CISPR/D/428/CC

COMPILATION OF COMMENTS ON COMMITTEE DRAFT

Project number: CISPR 12 Ed. 7.0	Reference number of the CD CISPR/D/427/CD
IEC/TC or SC CISPR/D	Date of circulation 2016-05-06
Title of the TC or SC: Electromagnetic disturbances related to electric/electronic equipment on vehicles and internal combustion engine powered devices

Title of the committee draft: Vehicles, boats and internal combustion engines - Radio disturbance characteristics - Limits and methods of measurement for the protection of off-board receivers
The above-mentioned document was distributed to National Committees with a request that comments be submitted
Report of comments See printout attached
Comments received – see annex ¹
DECISION OF THE CHAIRMAN (in cooperation with the secretariat) a <input type="checkbox"/> A revised committee draft will be distributed as a committee draft for vote (CDV) by (date) b <input checked="" type="checkbox"/> A revised committee draft will be distributed for comment by (date) 2016-12 c <input type="checkbox"/> The committee draft and comments will be discussed at the next meeting (date) NOTE In the case of a proposal <i>a</i> or <i>b</i> made by the chairman, P-members

Figure 8 – Antenna position when length of the vehicle/boat/device is smaller than the 3 dB beamwidth of the antenna N (number of antenna positions) = 1 and X (maximum gain reduction corresponding to the 2β antenna beamwidth angle) ≥ 3 dB, – Horizontal polarisation shown

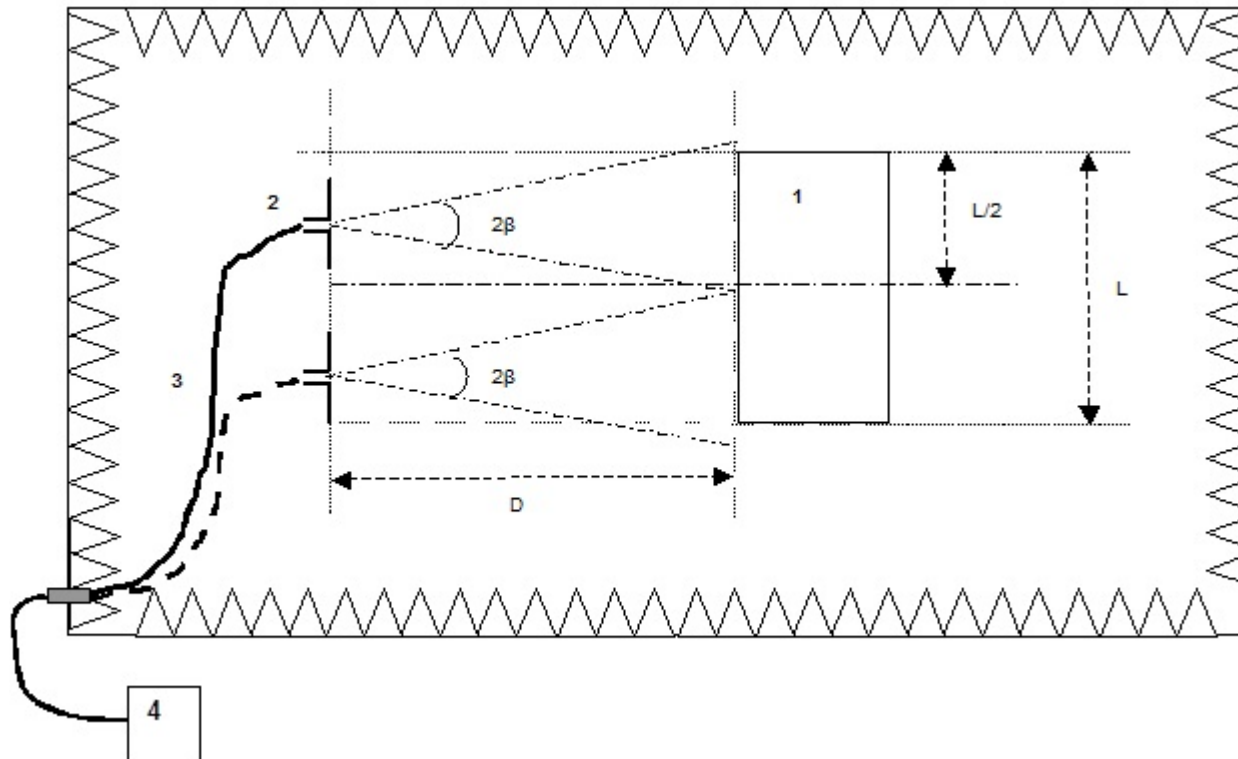
ANNEX FR-10

ANNEX FR-11

if the length of the vehicle/boat/device is smaller than the 3 dB beamwidth of the antenna, only one antenna position is necessary. The antenna shall be aligned with the middle of the total vehicle/boat/device length (see Figure 8)

if the length of the vehicle/boat/device is greater than the 3 dB beamwidth of the antenna, multiple antenna positions are necessary in order to cover the total length of the vehicle/boat/device (see Figure 9). The number of antenna positions shall allow to meet the following condition:

- The antenna shall be aligned with the middle of the total vehicle/boat/device length (see Figure 8)
- The applicable limits are the original limit values

- The antenna shall be aligned with the middle of the total vehicle/boat/device length (see Figure 8)
- the applicable limits are the original limit values minus a correction calculated from the antenna gain data (see Annex A).

Figure A.1 — Determination of the maximum antenna angle

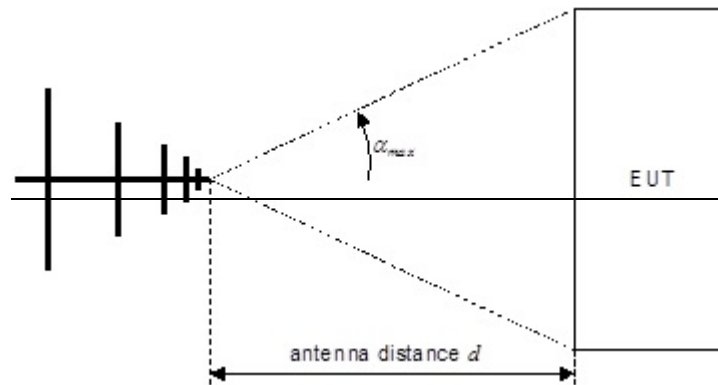
Calculate the maximum antenna angle α_{\max} from the vehicle dimensions, the antenna distance (vehicle surface — antenna reference point), and the antenna position (see Figure A.1).

Example: $d = 3$ m, vehicle length = 5 m $\rightarrow \alpha_{\max} = 40^\circ$.

In Figure A.1 replace α_{max} by β and $-a$ dB by $-X$ dB

Figure A.1 – Calculation of the resulting gain reduction a X

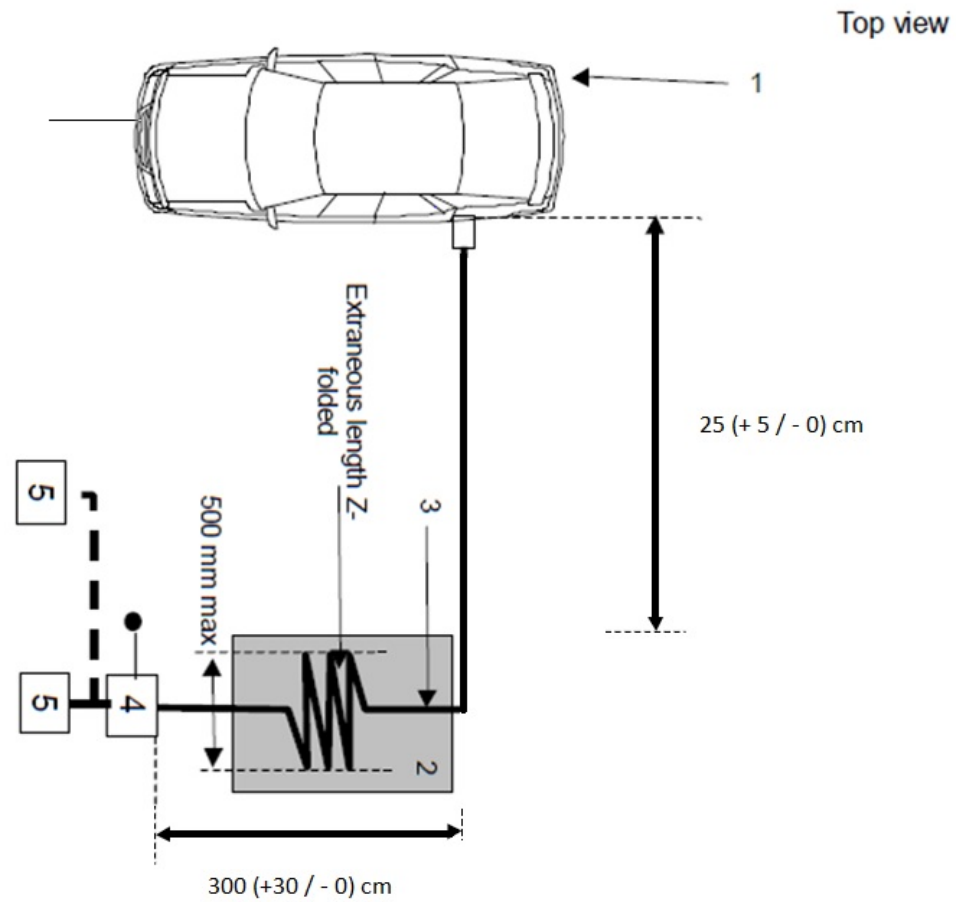
Calculate the alternative emission limit by subtracting from the original limit line the absolute value of the maximum gain reduction a_{max} :

Calculate the alternative emission limit by subtracting from the original limit line the absolute value of :

$$COR_{dB} = 3 - X_{dB}$$

Where X_{dB} is the maximum gain reduction

New proposal for lower half of Figure 10 - Example of test setup for vehicle with plug located on vehicle side

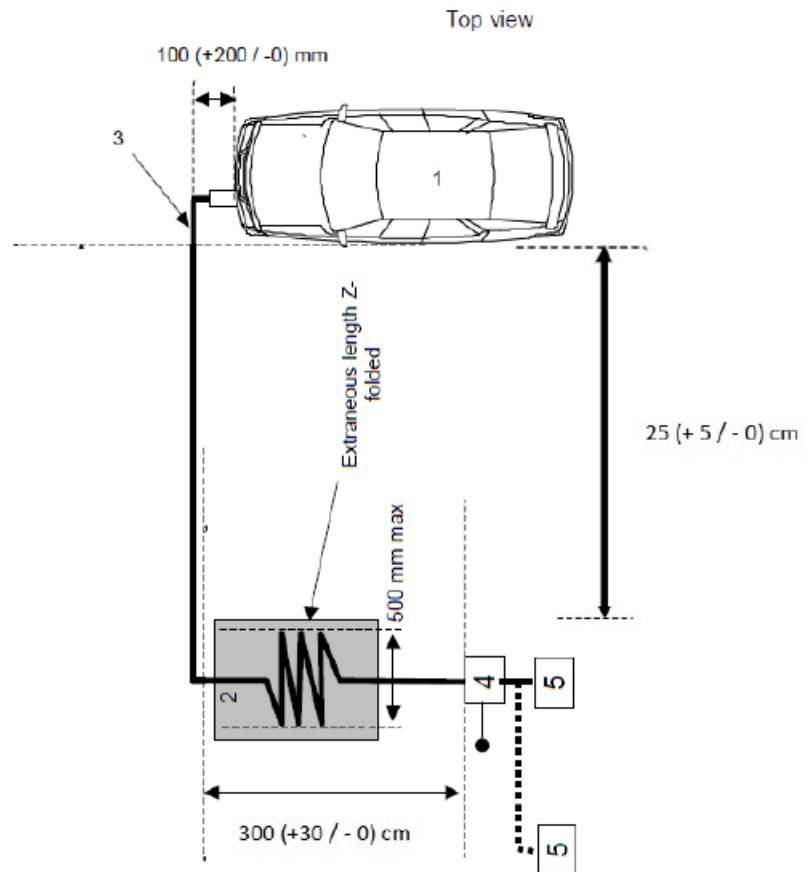
DE 22	581 592 669 681	5.4.2.2.4	Figure 10 Figure 11 Figure 12 Figure 13	Te	Key 1 reads "Vehicle/boat under test", but headline of clause 5.4.2 is "Test setup for vehicle in charging mode" and although the title of figure 10 is stating, that figure 10 is only showing an example, one might ask the question if this setup is suitable for boats.	Delete boat in Key 1	Not agreed, see CA-76
CA-89	586 – 587	5.4.2.2.3	Figure 10, caption	Ed	On the vehicle there is usually a socket, not a plug.	Please replace "plug" with "socket" in the caption in line 586. Also, please add a comma after "AC powered" inside the parenthesis from line 587.	Agreed
NO-03	586		Figure 10	te	This is a very nice drawing of a vehicle, but a schematic with slightly more details is required too to be sure that things are connected in the	Please add a figure with a schematic to complement the information in the drawing in Figure 10.	To be discussed at the next WG1 meeting

Modified version of the lower half of Figure 10:
